MODEL 10007

BELT DRIVE STALLION KIT

ALTERATIONS TO EXISTING MACHINE

* CLUTCH CONSISTS OF ITEM K AND ITEM L

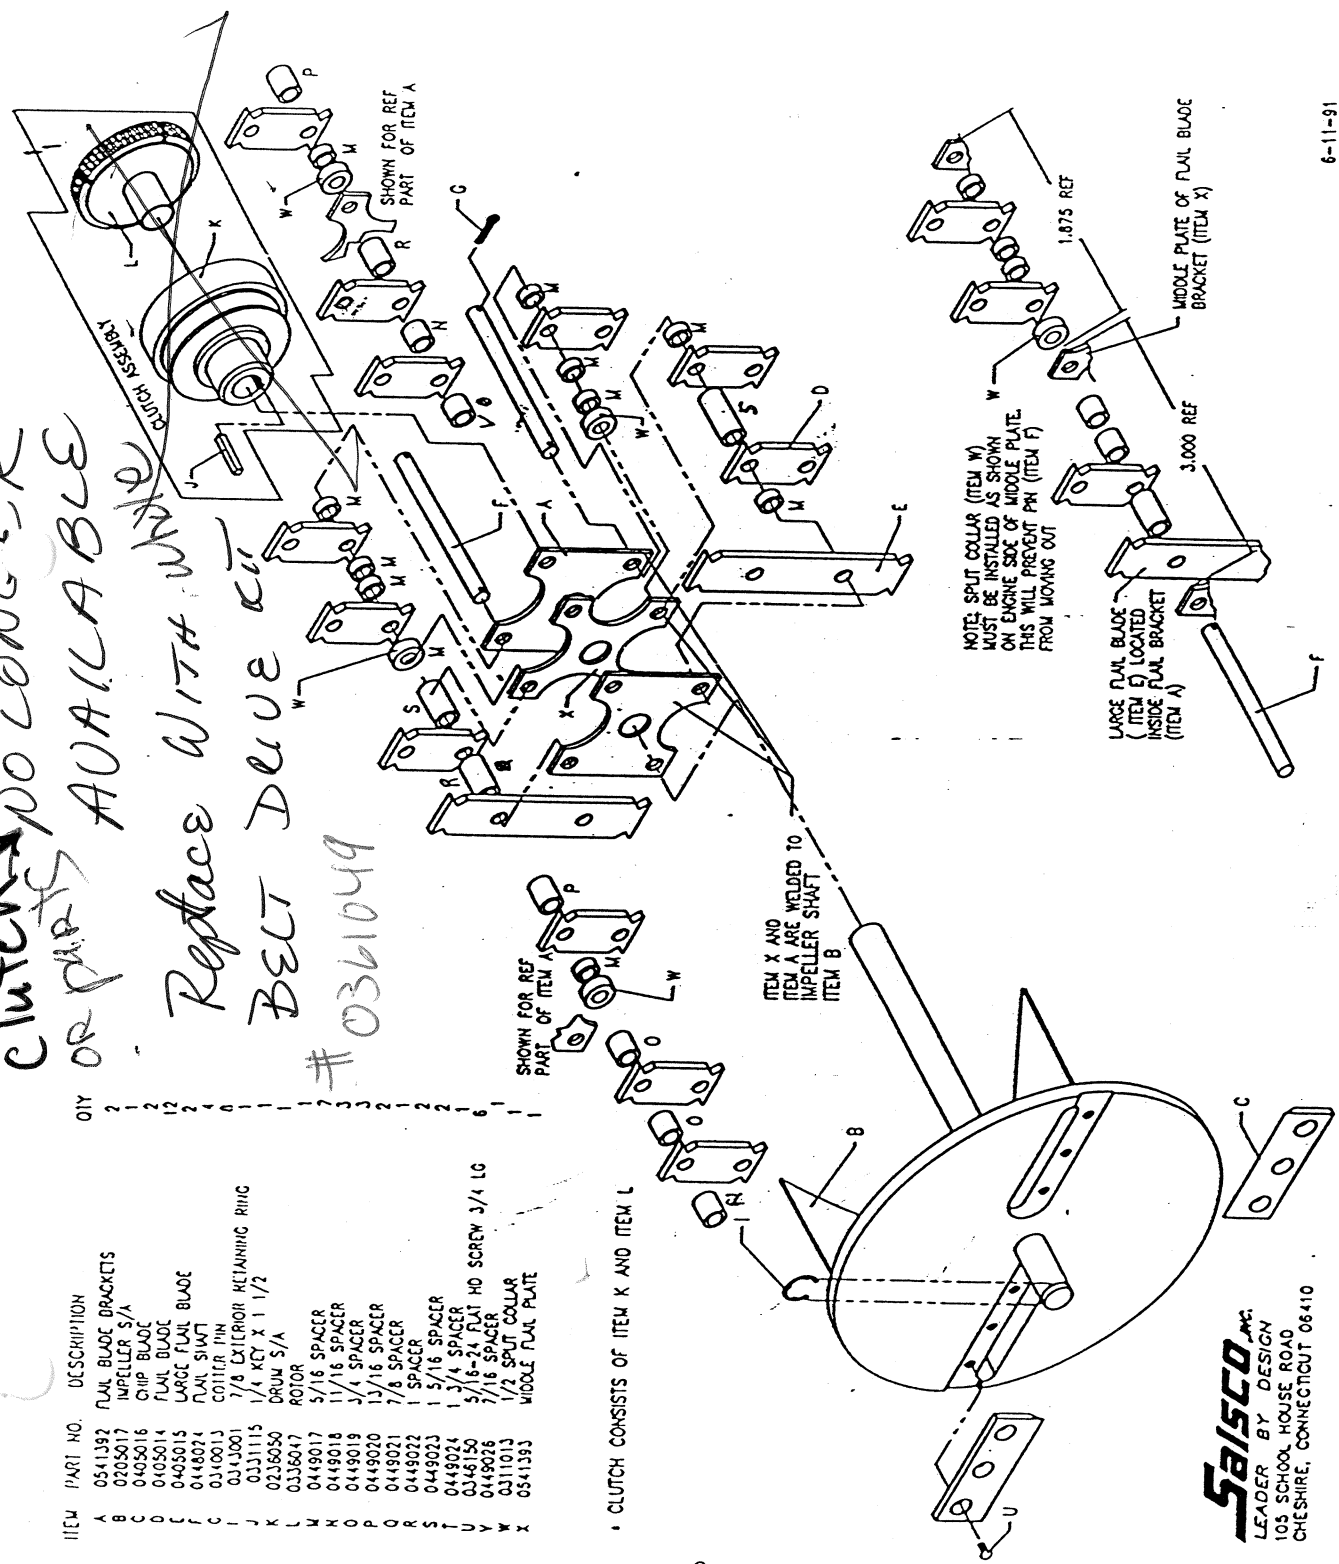
clutch no longer
or parts available

Replace with water
Belt drive cut
#0361049

BELT DRIVE STALLION KIT

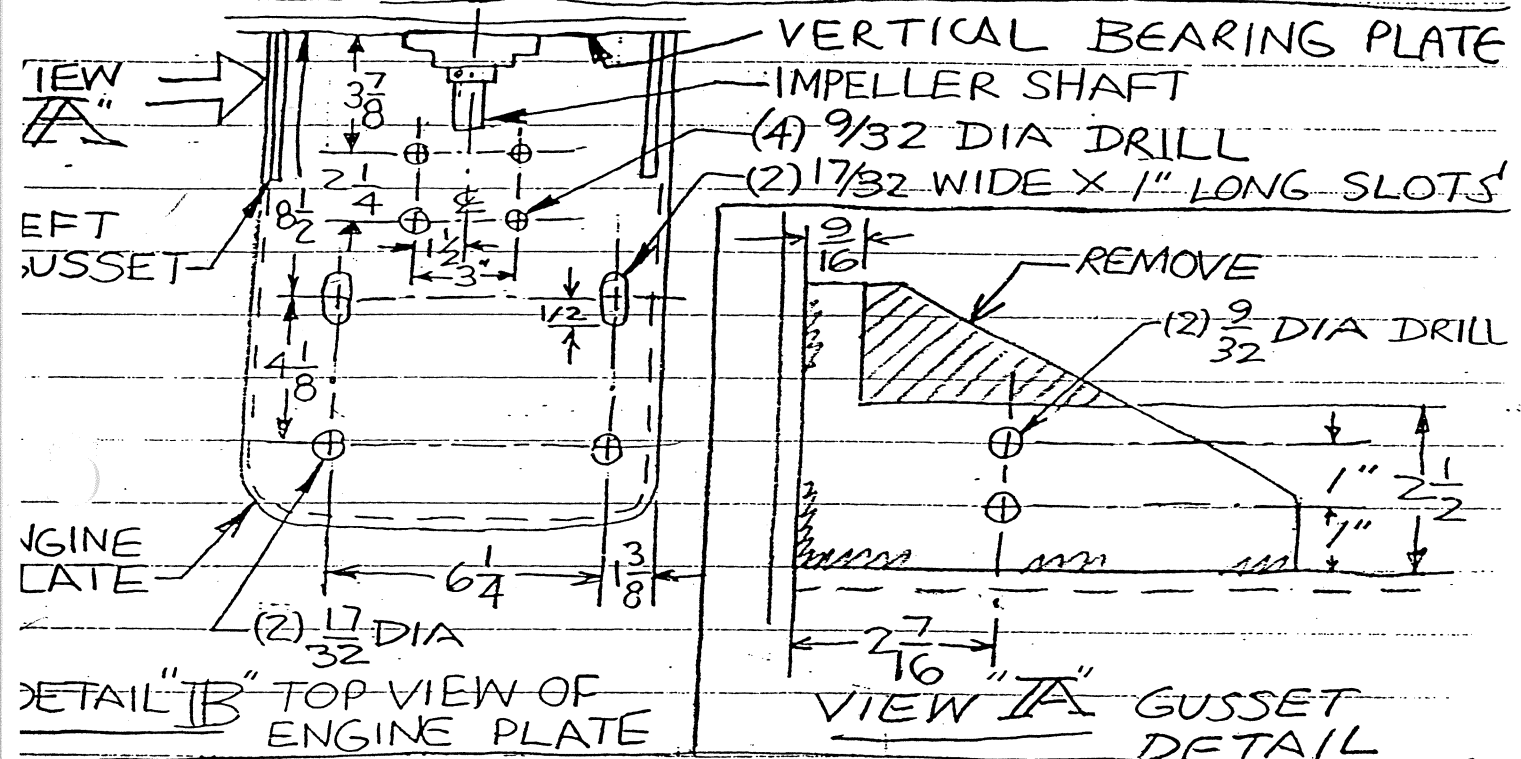
1. GUSSET ALTERATIONS

a. CUT A NOTCH AND DRILL (2) HOLES THROUGH LEFT GUSSET PER VIEW "A".

2. ENGINE PLATE ALTERATIONS

a. DRILL (4) $\frac{9}{32}$ DIA HOLES PER DETAIL "B". LOCATE HOLE CENTERS FROM ENGINE PLATE CENTER LINE AND THE VERTICAL BEARING PLATE.

b. DRILL (2) $\frac{17}{32}$ DIA HOLES AND (2) $\frac{17}{32}$ X 1" SLOTS PER DETAIL "B". LOCATE HOLE CENTERS FROM RIGHT OUTSIDE EDGE OF ENGINE PLATE AND THE VERTICAL BEARING PLATE.

ALTERATIONS TO EXISTING MACHINE (CONTINUED)

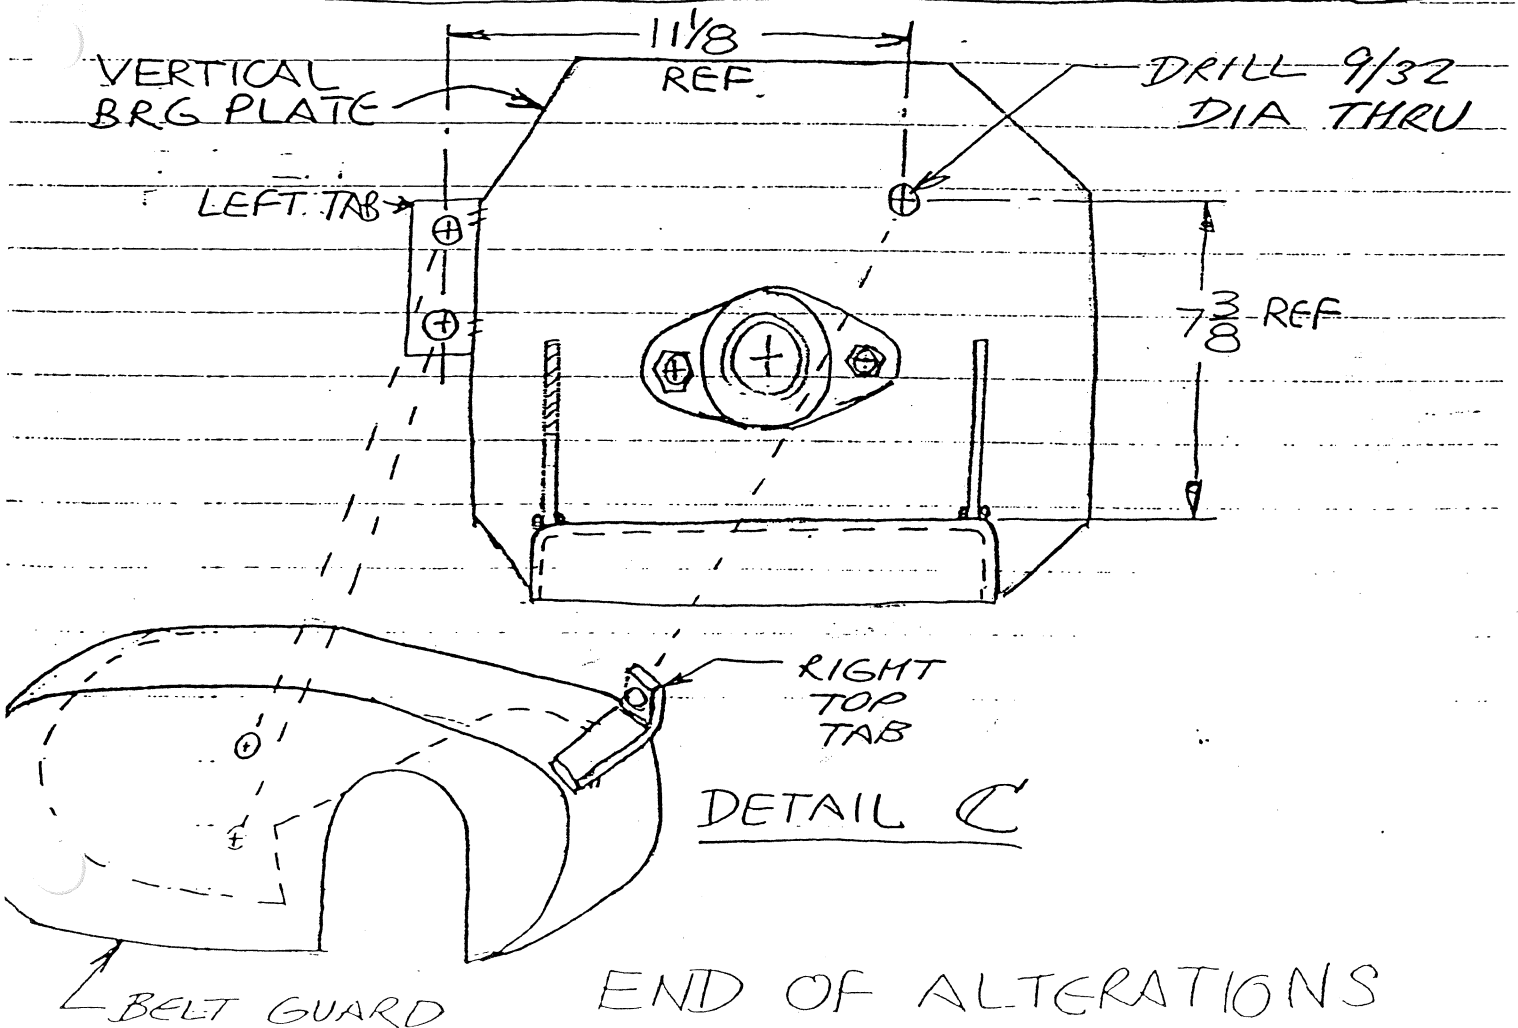
3. VERTICAL BEARING PLATE ALTERATION

A. DRILL $\frac{9}{32}$ DIA HOLE THROUGH VERTICAL BEARING PLATE PER DETAIL "C".

B. BEST METHOD - TRANSFER HOLE FROM GUARD. TEMPORARILY BOLT ON BELT GUARD. USE THE (2) HOLES ON INSIDE FACE OF GUARD AND THE (2) HOLES OF TAB LOCATED ON TOP LEFT EDGE OF VERTICAL BEARING PLATE.

THEN TRANSFER HOLE CENTER FROM THE RIGHT TOP TAB OF BELT GUARD TO THE VERTICAL BEARING PLATE.

PN0361049

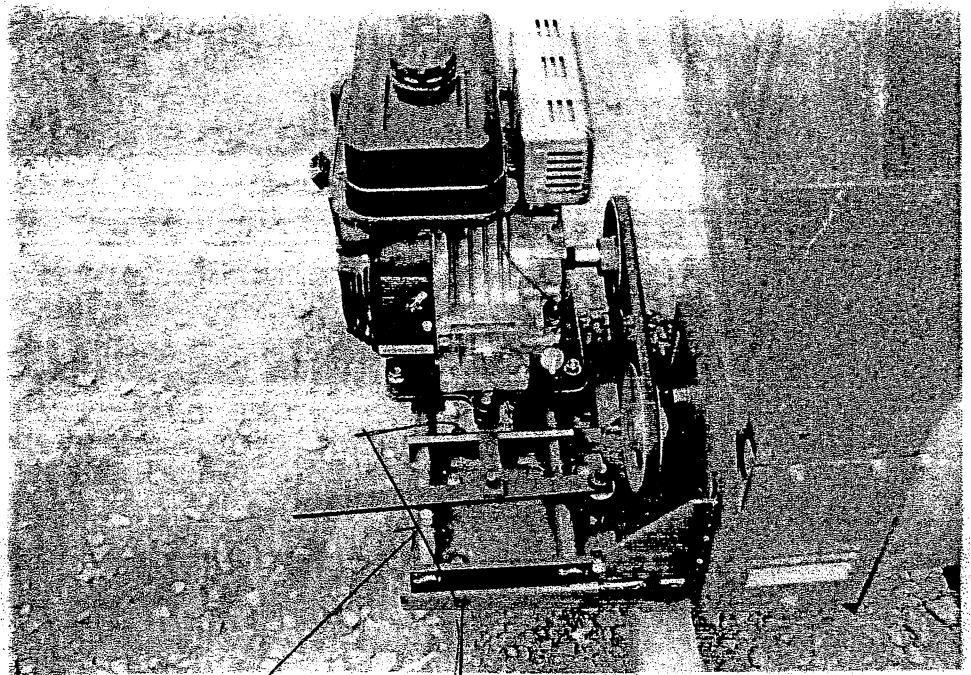
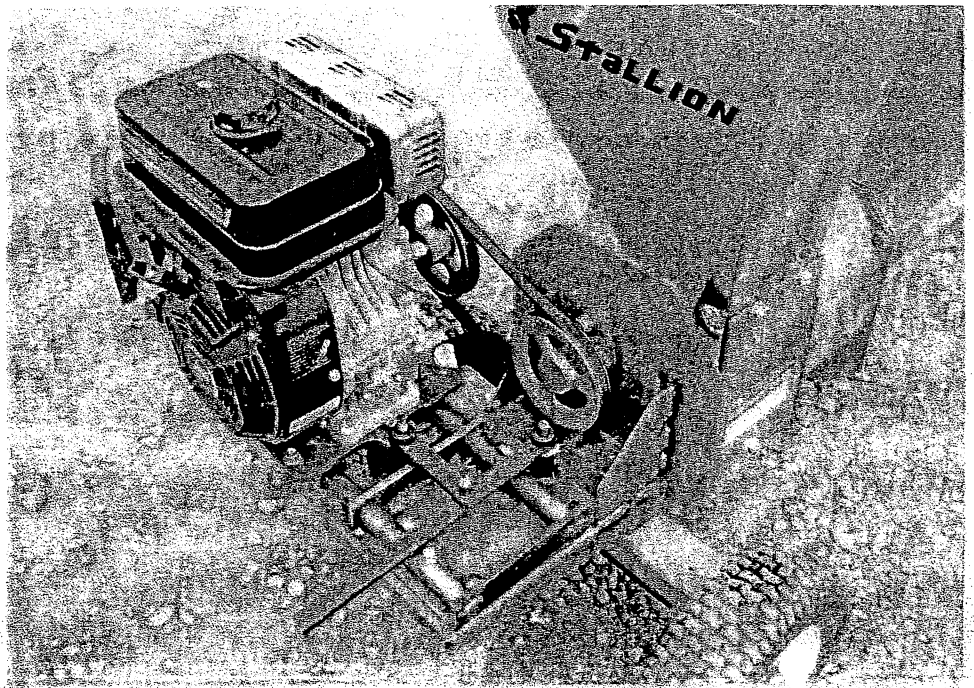
Install Split
Collar with bent
rod #11010

Drill 2 holes for
Bungee cord provided # 08013
